Job Title
**CONVERSION OF REAR
FIRST & SECOND FLOORS
TO RESIDENTIAL. NEW THIRD
FLOOR RESIDENTIAL.**

Drawing
**PROPOSED
FIRST AND SECOND FLOOR
PLANS**

Drawing No
PA - 02

Revision No
P9

FIRST FLOOR PLAN

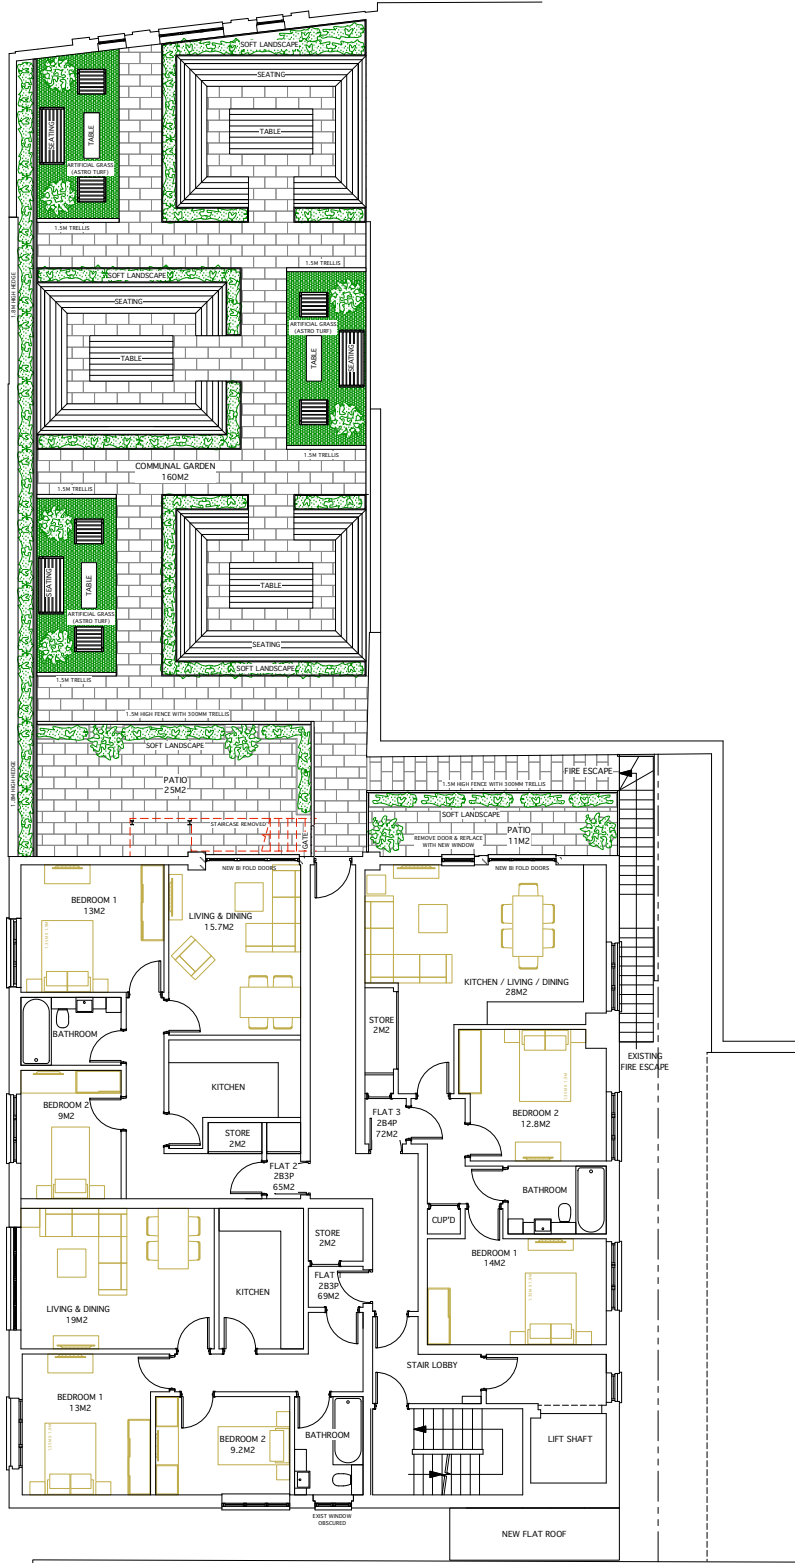
REVISION P5: 30.01.24
REVISIONS CARRIED OUT IN ACCORDANCE WITH THE PRE APP MEETING ON THE 25.10.23 WITH LONDON BOROUGH OF HILLINGDON.
FLAT 3 CHANGED FROM A 3 BED TO A 2 BED FLAT.
ACCESS TO FLAT 3 WILL BE FROM THE MAIN INTERNAL STAIRS PASSING THROUGH A CORRIDOR BETWEEN FLATS 2 & 3. FLATS REVISED TO SUIT ALTERATION. THE EXISTING EXTERNAL FIRE ESCAPE STAIRCASE TO REMAIN AS EXISTING.
FLAT ROOF BETWEEN FLATS 2 & 3, TO BE A COMMUNAL GARDEN WITH THE SITE BOUNDARY WITH NUMBER 120 HIGH STREET TO HAVE AN OBSCURED SCREEN OF 1.8M HIGH.
ALL AS REQUESTED BY L&L.
REVISION P6: 11.03.24
REVISIONS CARRIED OUT TO WINDOWS WITH A BLUE REVISION CLOUD. SOFT LANDSCAPE SHOWN ON FIRST FLOOR PATIOS.
REVISION P7: 24.05.24
FRONT FIRST FLOOR FLAT REMOVED AND RELOCATED TO THIRD FLOOR ON MAIN BUILDING. COMMUNAL GARDEN AREA INCREASED. SCHEDULE OF ACCOMMODATION REVISED.
REVISION P8: 30.05.24
FIRST FLOOR: FLAT 1 BED 2 WINDOW REVISED. ADDITIONAL LANDSCAPE ADDED TO COMMUNAL GARDEN.

SECOND FLOOR PLAN

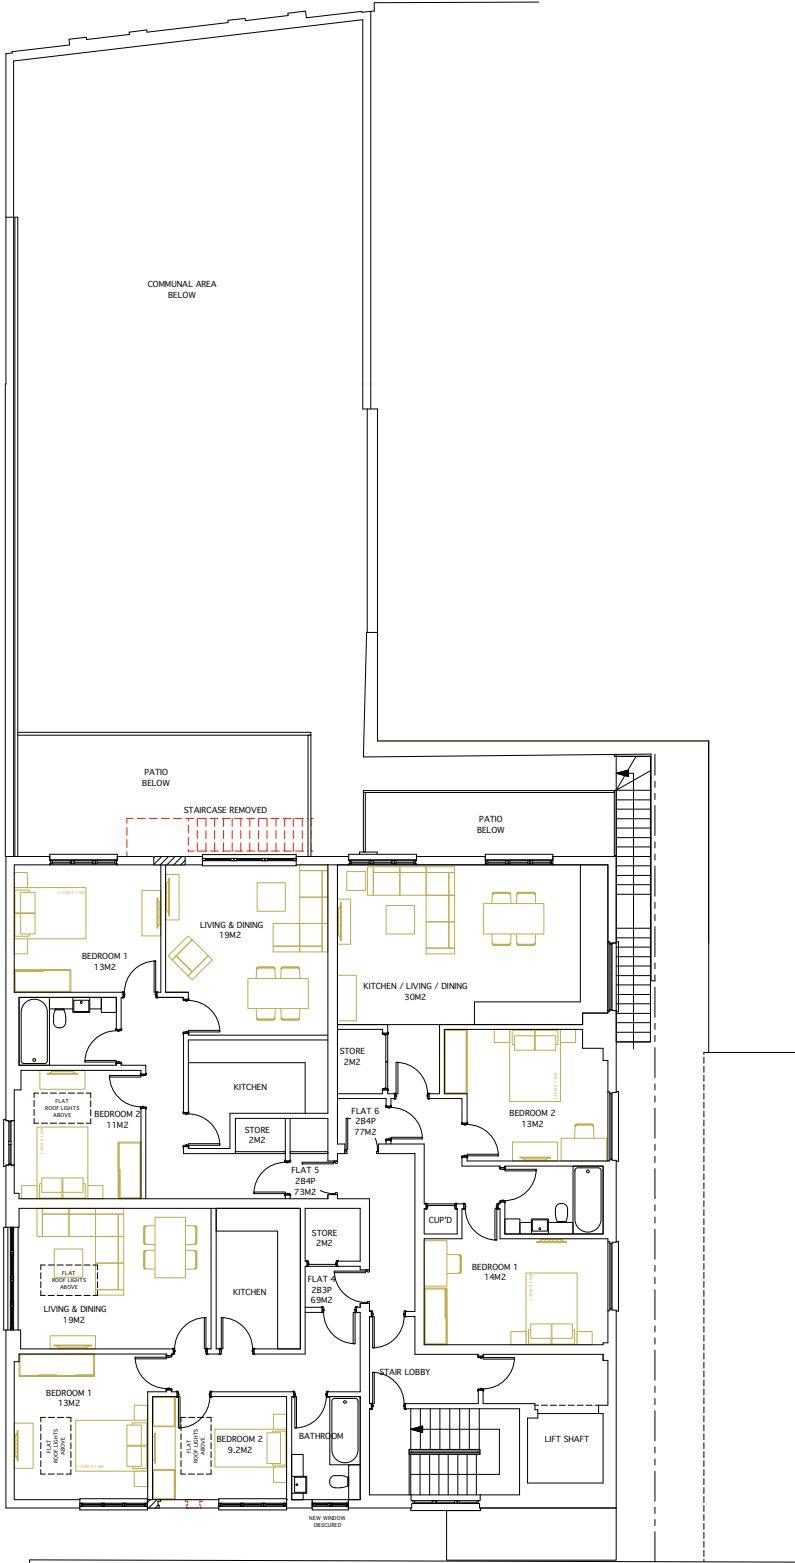
SECOND FLOOR: FLAT 4 BED 1 & 2 WINDOWS REVISED.
REVISION P9: 08.10.24
WINDOWS NOTED AS FOLLOWS TO BE OBSCURED UP TO 1.7M FROM FFL.
FLAT 1: BEDROOM 1 AND LIVING & DINING ROOM.
FLAT 4: LIVING & DINING ROOM.
PATIO TO FLAT 2 INCREASED TO 2.3M2.
FLAT 4: FLAT ROOF LIGHTS ADDED TO LIVING & DINING AND TO BEDROOM 1 & 2. FLAT 5: FLAT ROOF LIGHT ADDED TO BEDROOM 2.
PRIVATE PATIO TO FLAT 2 INCREASED IN SIZE. COMMUNAL GARDEN LAYOUT REVISED. BOUNDARY SCREENING ALONG SIDE PASSAGE ON FIRST FLOOR REVISED TO GREEN HEDGE.
